Hi-Fi Products
Service Bulletin

Model: DTC-57ES / 75ES / 87ES / 700 / 750

No. 317

Subject: Momentary loss of audio at the same point on a known good tape.

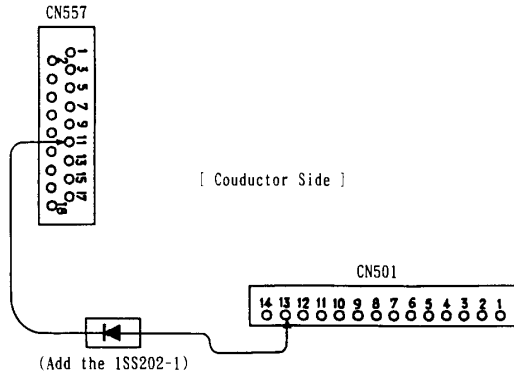
Add one diode (shown in the chart below) between pin no. 4 on connector CN302 and pin no. 3 on connector CN307 on the Main board (mount as shown in diagram below).

Add one diode (shown in the chart below) between pin no. 11 on connector CN557 and pin no. 13 on connector CN501 on the Main board (mount as shown in diagram below).

Add one transistor (shown in chart below) between pin no. 11 on connector CN501, pin no. 6 on connector CN501 and pin no. 3 on CN507 on the Digital board (mount as shown in diagram below).
